Remarks

In the Drawings

37 CFR 1.83(a) Objections

Fig. 10

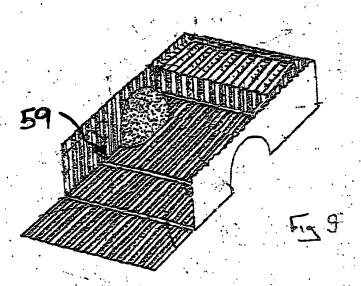
- (1) Front wall latch means 85 was not shown. Front wall latch means 85 is shown on Figure 10. It was mislabeled as "84". A correction has been made.
- (2) In Figure 1, side wall 38 was mis-marked as 22. A correction has been made.
- (3) Lower latch means 59 was not clearly shown in Figure 2. The Lower latch means is better seen in Figures 1 and 9. A correction has been made to the Specification to better illustrate this feature.
- (4) In Figure 3, the Examiner noted some unexplained error. Applicant assumes that the lead line to horizontal protrusion 55 was not pointing to its feature and that the lower latch means 59 was not seen. The lead line has been changed and the Specification has been amended to better describe lower latch means 59.

FIG. 16

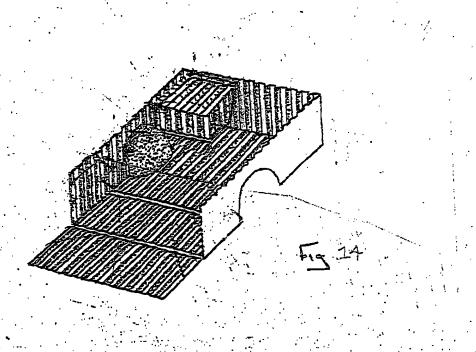
The Examiner objected to the drawings pursuant to 37 CFR 1.83(a) for failing to show every feature of the claimed invention. Applicant submits that the two living hinges as claimed in claims 14, 29, 30, and 53 are illustrated in Figures 15 and 16. The living hinges enable the divider to fold in two places to create a compartment.
